Planning Commission Public Hearing

SUBJECT: DR17-1153, HIGHLINE CAR CARE

Planning Commission Comments from Study Session conducted on February 7, 2018.

SITE PLAN

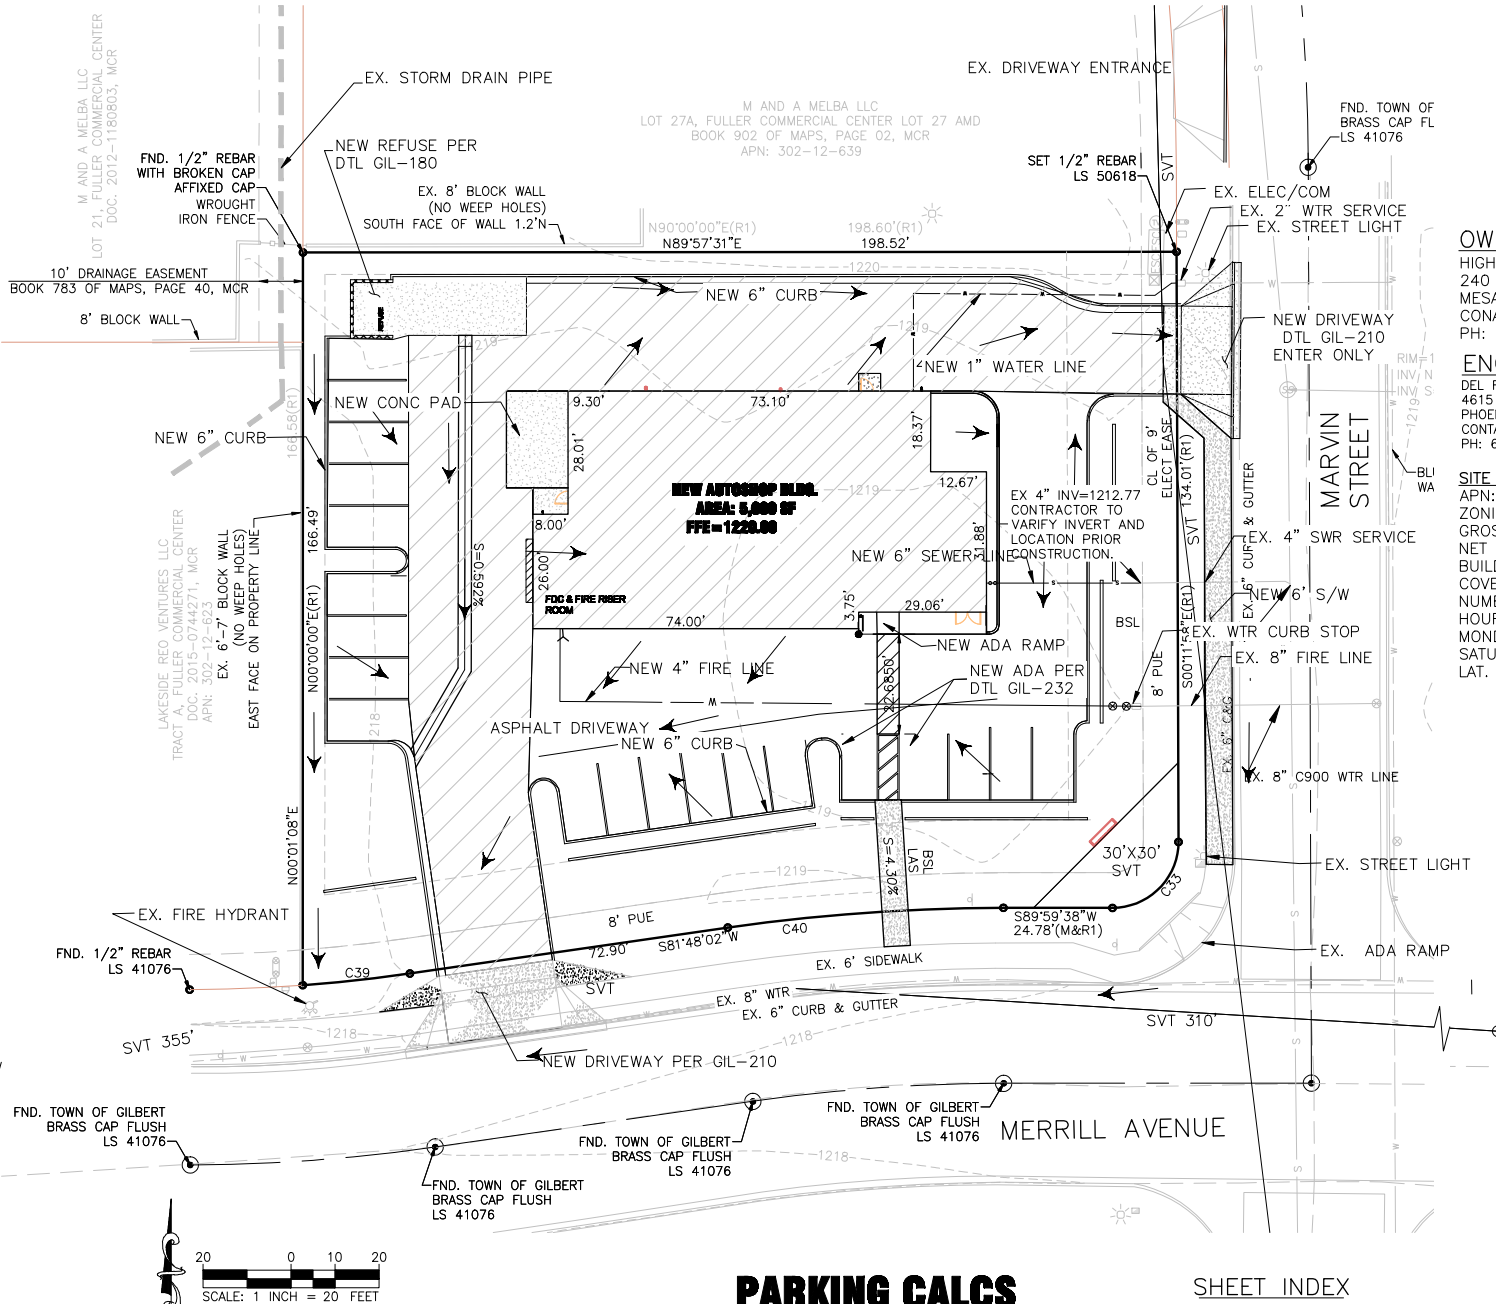
- Planning Commission requested the possibility of continuing the blue metal coping near the roof of the building and making it come around to the west elevation.
 - The applicant has accommodated said request.
- Planning Commission questioned the requirement for an ADA pedestrian connection to the sidewalk fronting Merrill Avenue.

- The applicant has revised their site plan to address this connection.
- Planning Commission asked for clarification on the location of the trash enclosure.
 - The applicant shows this enclosure at the northwest corner of the site.
- Planning Commission had some concerns with trees too close to the trash enclosure.
 - The applicant has addressed this concern by removing these trees.
